Subject: Oconee Nuclear Station  
Docket Numbers 50-269, 270, and 287  
License Amendment Request associated with the  
Digital Control Rod Drive Control System (CRDCS)  
Modification  
Technical Specification Change (TSC) Number  
2003-09

The existing relay based CRDCS is being upgraded to a solid-state programmable Digital CRDCS to resolve obsolescence and age-related degradation issues. This upgrade replaces the CRD/ Reactor Trip Breakers, the electronics and controls contained in the CRD cabinets located in the Cable room and the Operator Control Panel (OCP) located in the Control Room. Duke expects these changes to enhance the reliability of the CRDCS through the extended life of Oconee Nuclear Station.

Duke proposes to revise Technical Specification 3.3.4, "Control Rod Drive (CRD) Trip Devices," to add requirements associated with the Digital CRDCS. Since ONS Technical Specifications are common to all three units, Notes will be used to indicate the applicable requirement for each unit based on the status of the modification. The proposed change to TS 3.3.4 adds a Limiting Condition for Operation

FIGURE 1

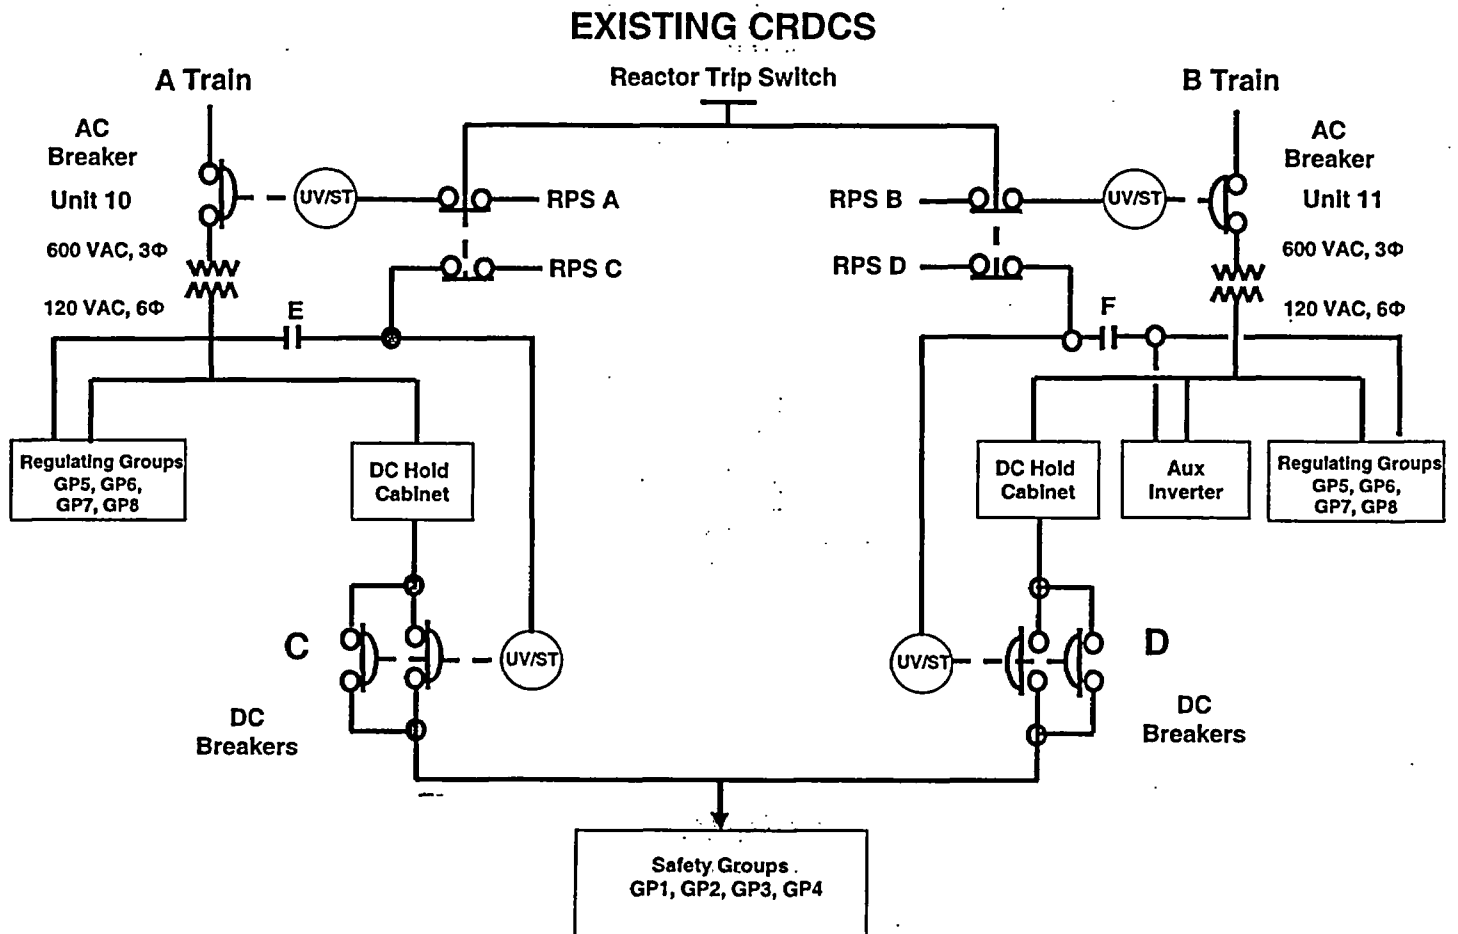
The existing relay based Control Rod Drive Control System (CRDCS) (refer to Figure 1 on page 10 for simplified diagram) is being upgraded to a solid-state programmable digital CRDCS to resolve obsolescence and age-related degradation issues. A Technical Specification change is needed to reflect the new design.

FIGURE 2

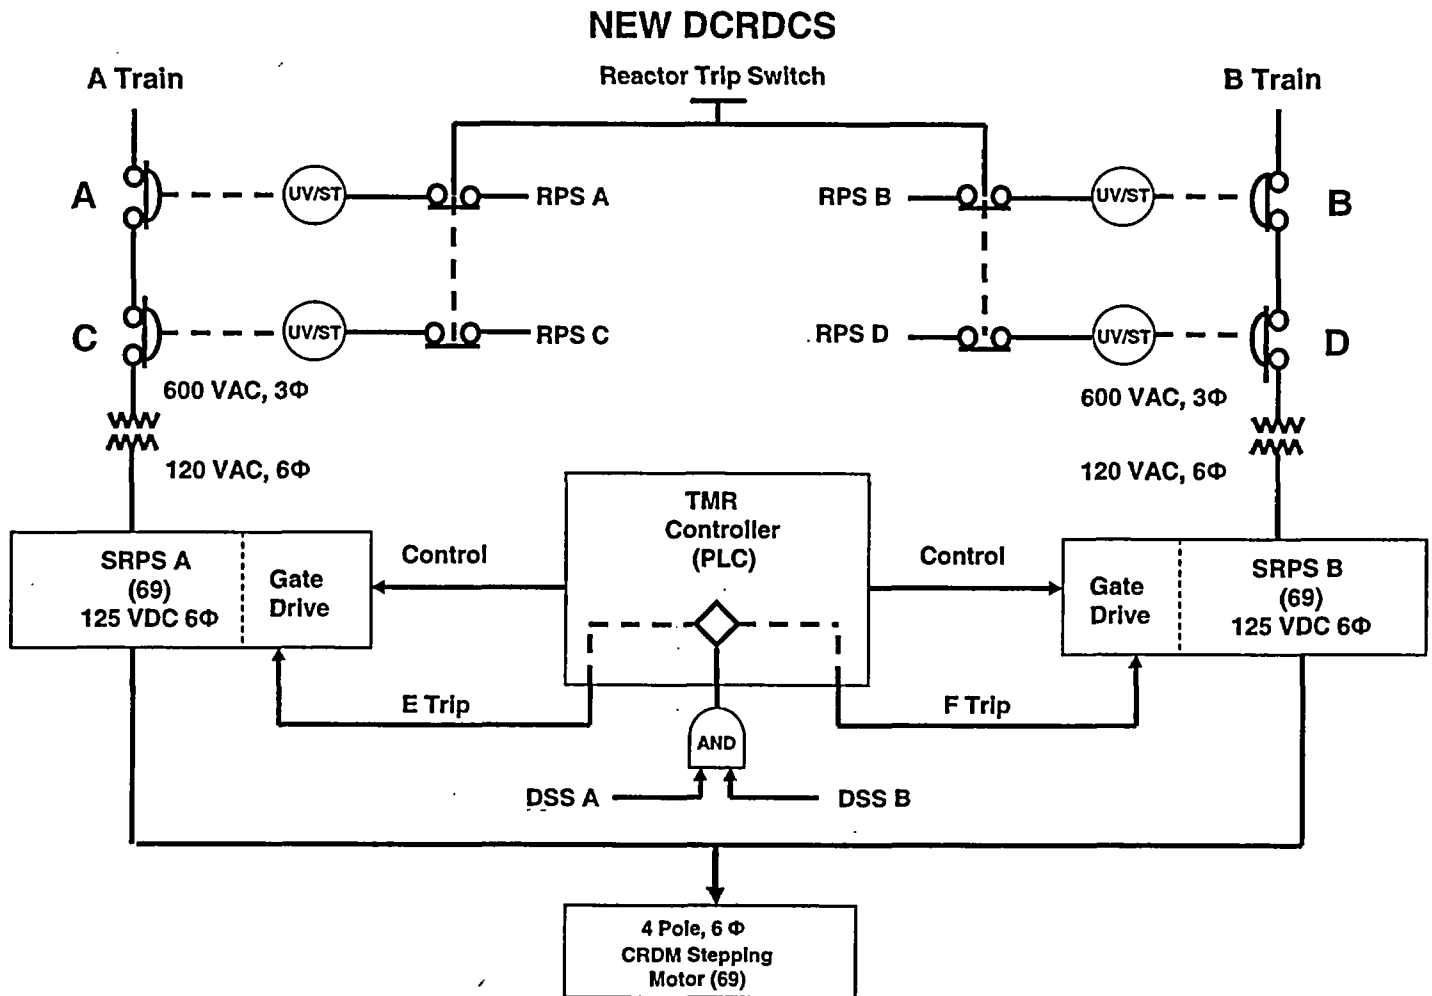
The new digital Control Rod Drive Control System (CRDCS) will be powered from two independent power supplies. Each of these power supplies will connect to the digital CRDCS via two RTBs connected in series (refer to Figure 2 on page 11 for simplified diagram). This arrangement of parallel feeds,
